RESPONSE TO CEC STAFF DATA REQUEST SET 2 (60-85)

STACK Trade Zone Park (21-SPPE-02)

SUBMITTED TO: CALIFORNIA ENERGY COMMISSION

September 2022

PARKING GARAGE - LEVEL 1
1: 30

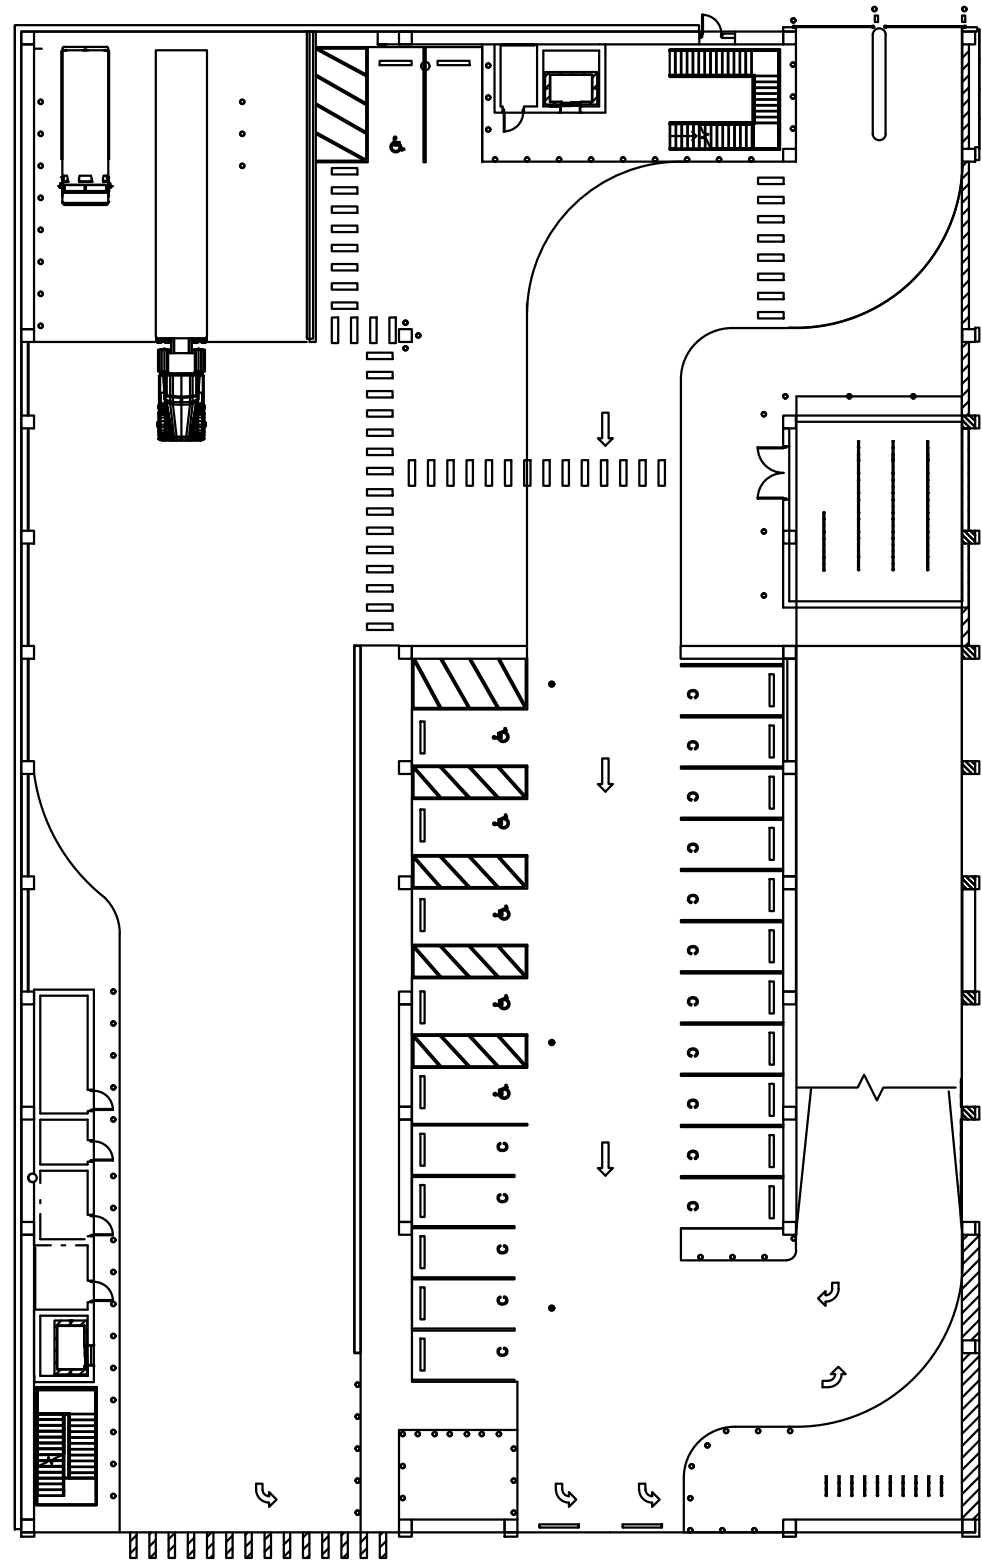
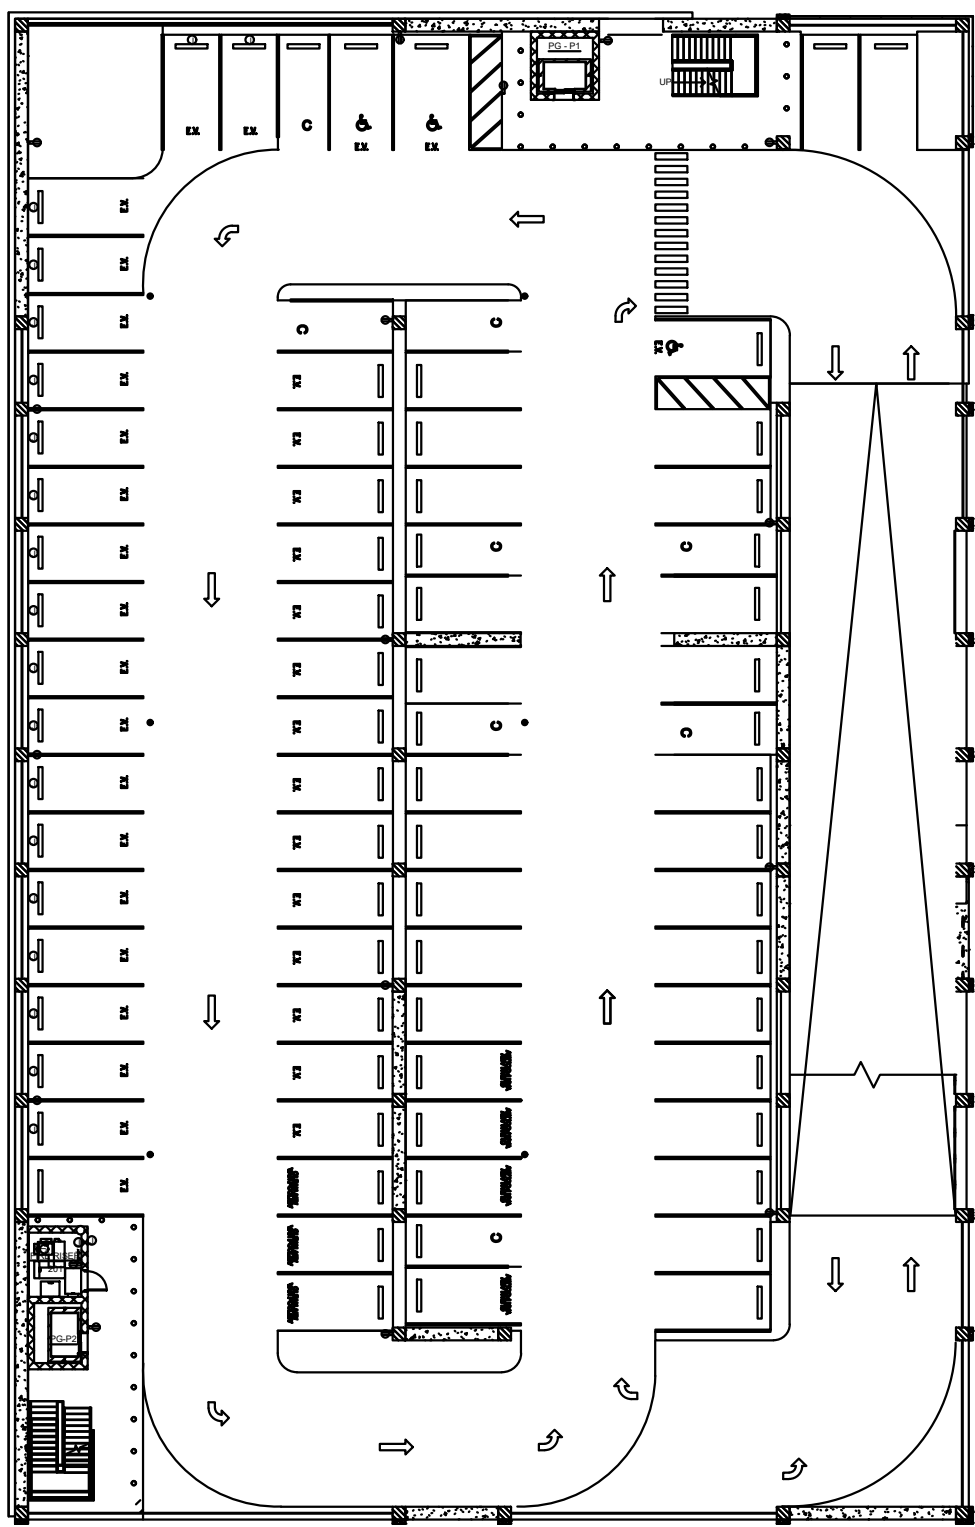
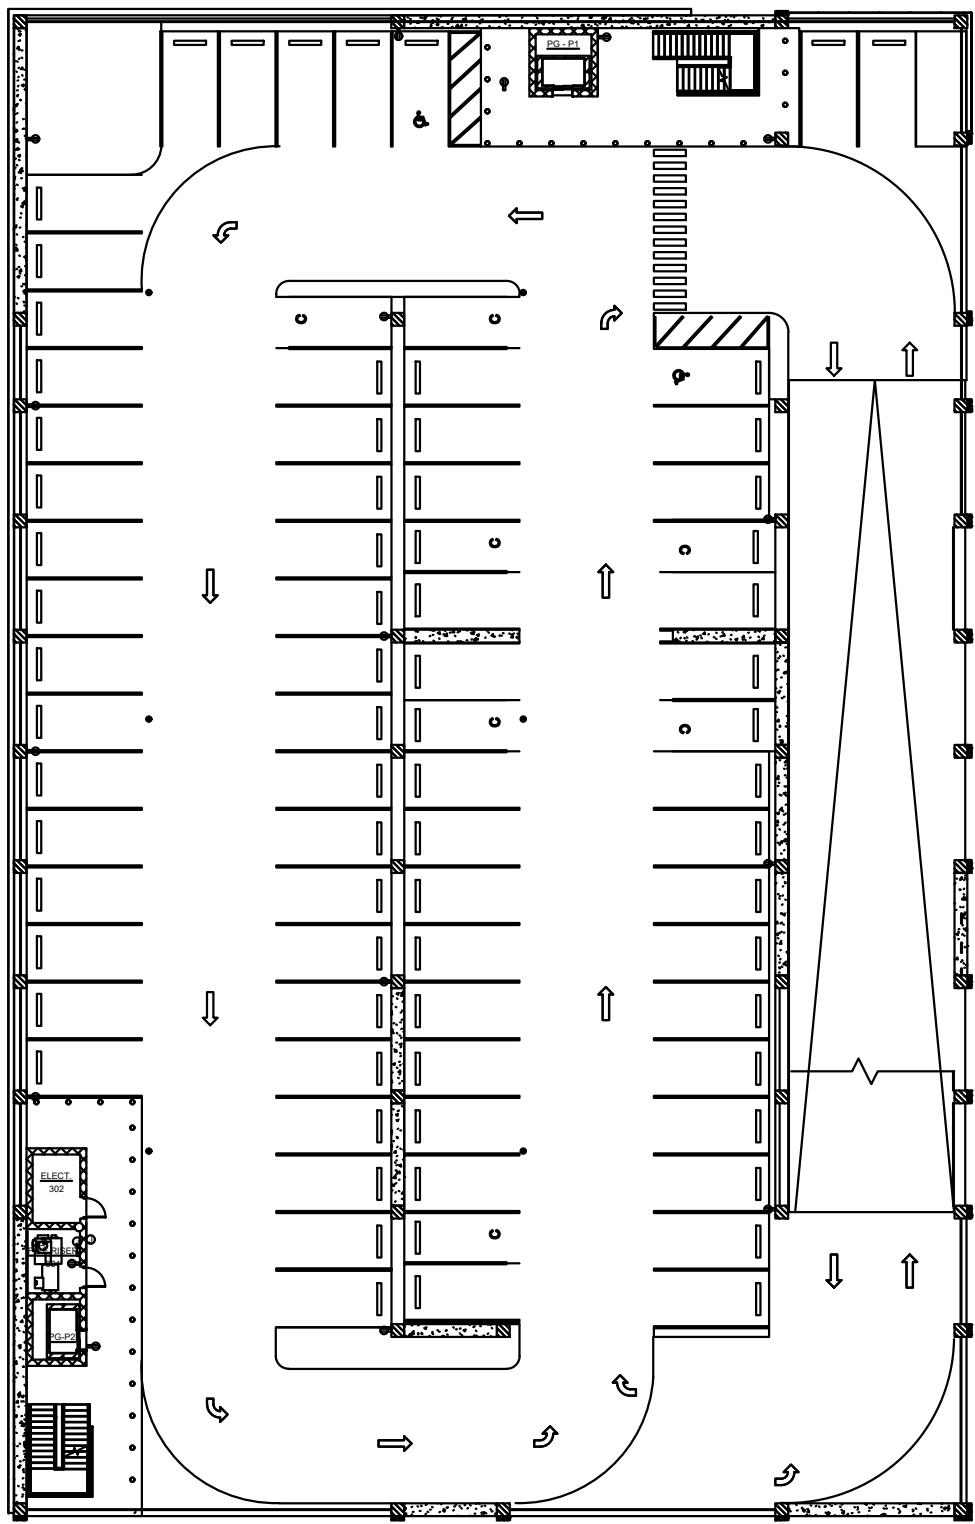
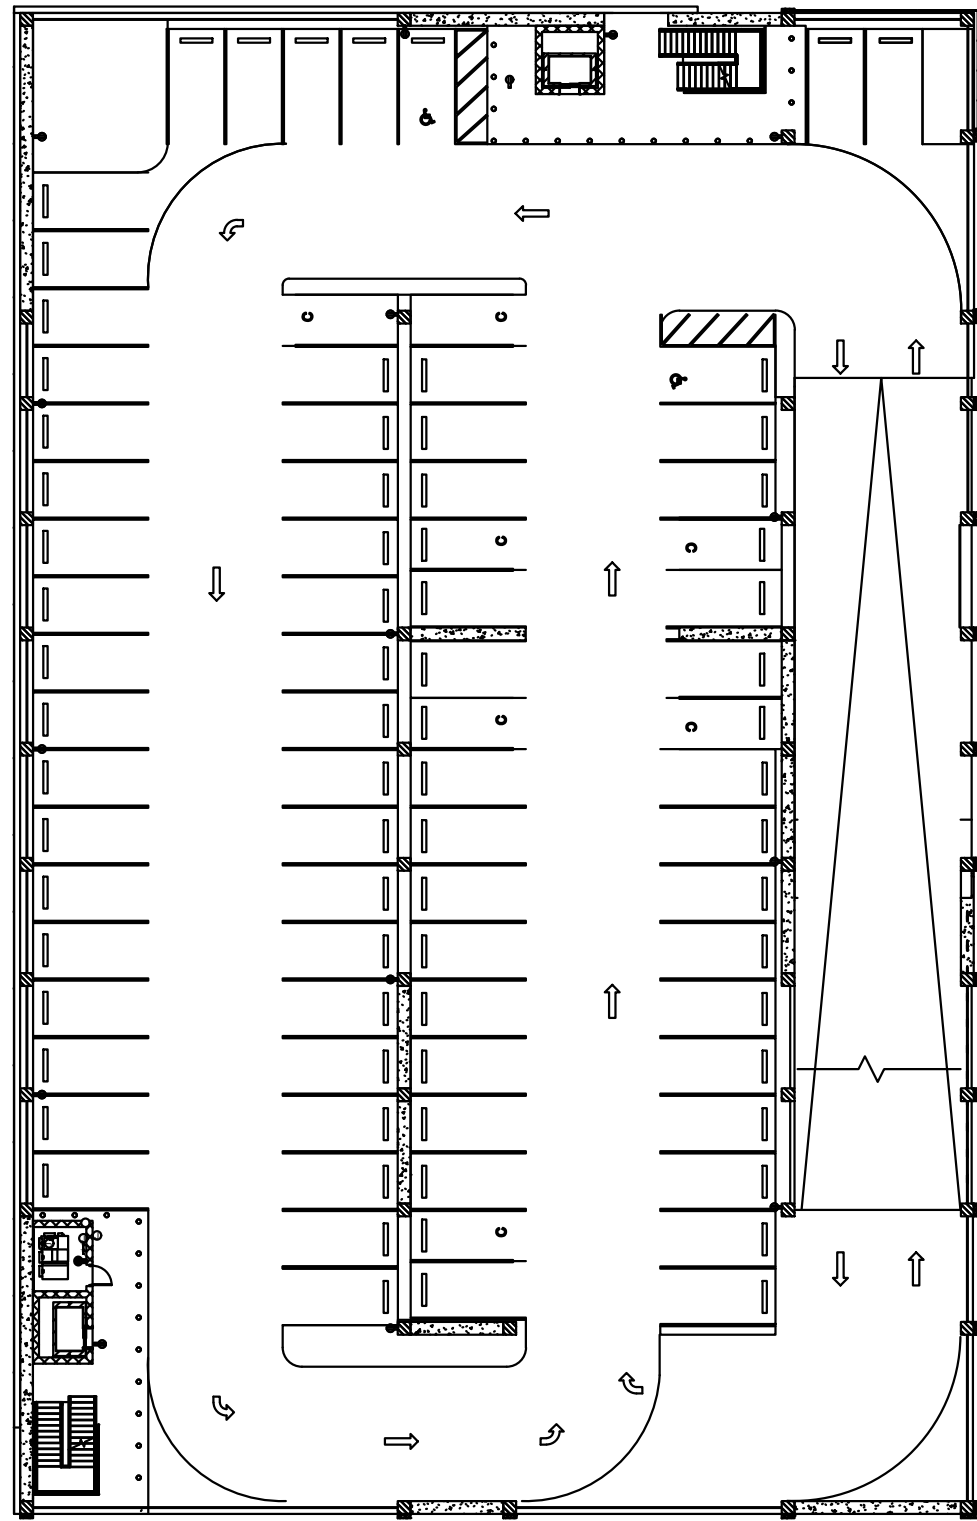
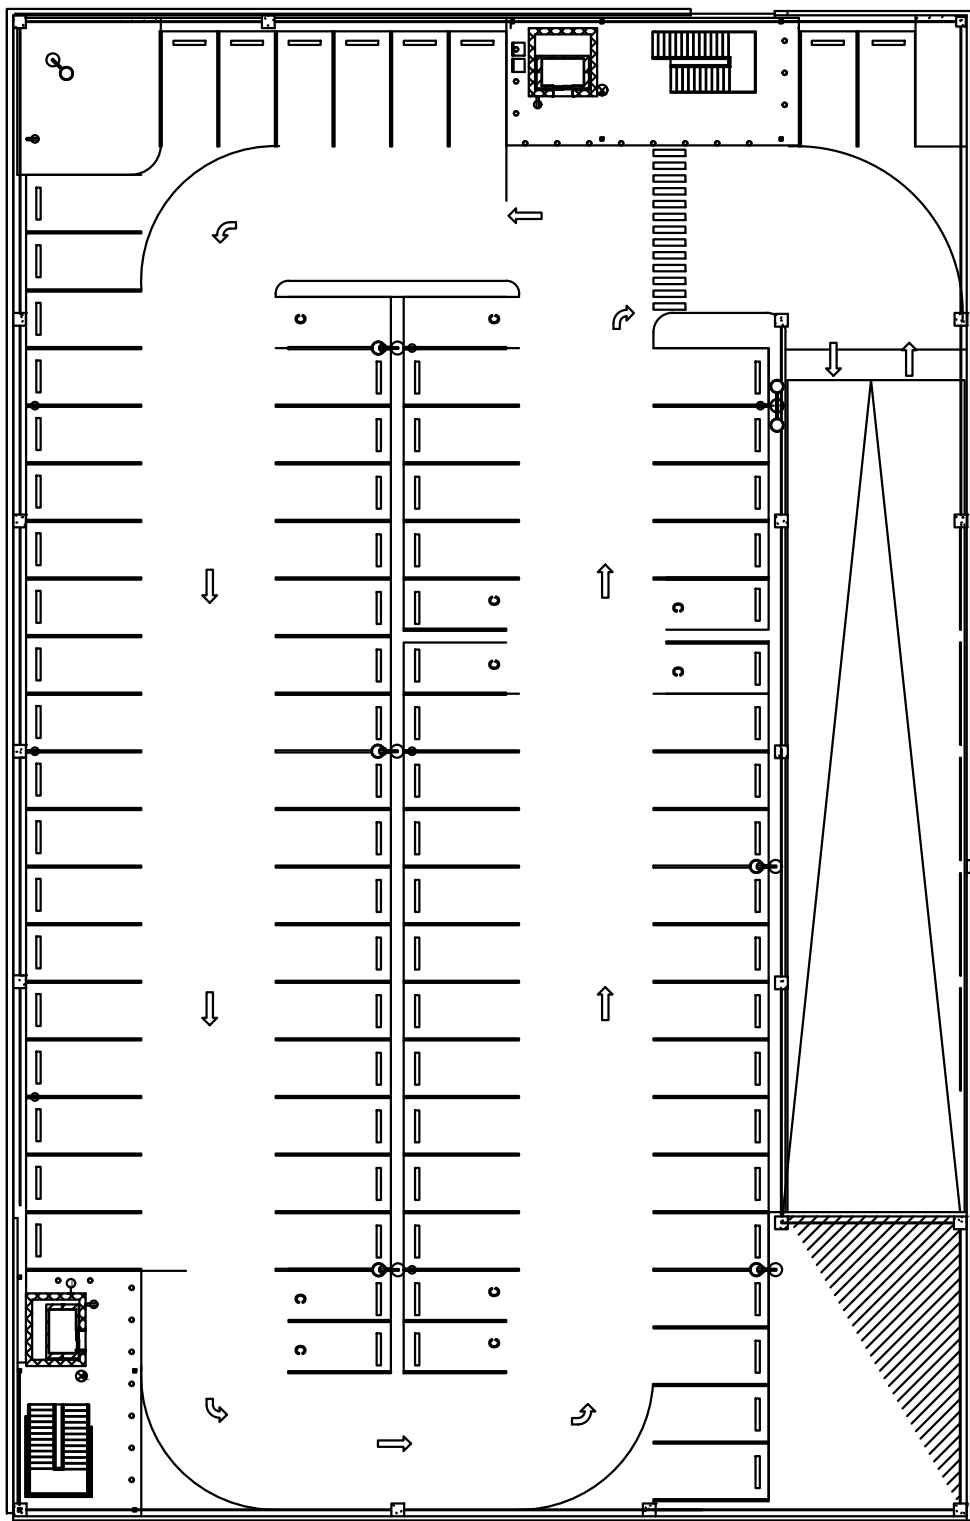
78. Please provide details on the surface parking and confirm the number of parking spaces, including accessible or other classification (such as EV- electric vehicle).

79. Please update Appendix GHG DR-34 Figure 3.1 and Figure 2.2-4 to clearly show the location of the surface parking spaces and parking garage.

Please See Appendix LU DR-73. All references to the Site Plans should be to the drawings contained in the LU DR-73.
